Cumberland Cluster Schools (SSD-43065987)

Bus Link Road - Design Modification

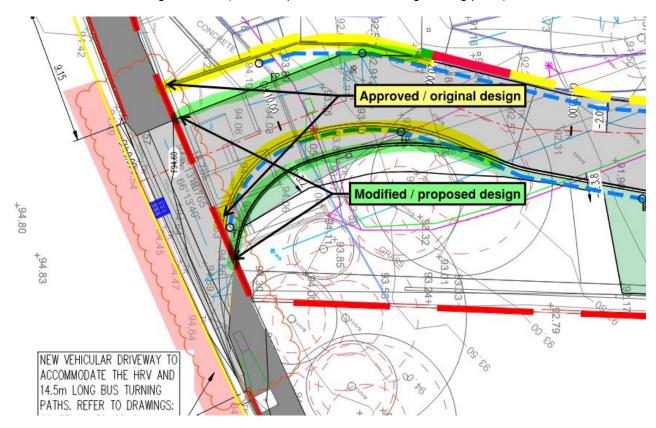
As part of ongoing design development, it is proposed to realign the exit driveway approximately 2m to the east, as illustrated in the figure below (marked up extract from civil engineering plans):

As the driveway is a left-out exit only, the proposed change results in the driveway moving downstream from oncoming traffic. Buses exiting the site will have marginally improved visibility compared to the original design, although at this scale the differences are negligible.

The revised design will reduce the severity of the S-bend for buses as they move from the bus stops towards the exit driveway, providing an improved user/driver experience and marginal improvements to manoeuvring.

The revised design for the driveway is based on swept paths for a 14.5m Long Rigid Bus being able to turn out of the site without utilising the right-turn lane into Tintern Avenue, which is consistent with the approved design.

Buses exiting the site will be further from the signalised pedestrian crossing, however as buses will be turning in the opposite direction with no conflicting pedestrian/vehicle flows, this element is neither worsened nor improved.

The width of the driveway, and therefore the overlapping zone for vehicle and pedestrian activity, is not affected by the proposed design change (but is simply relocated).
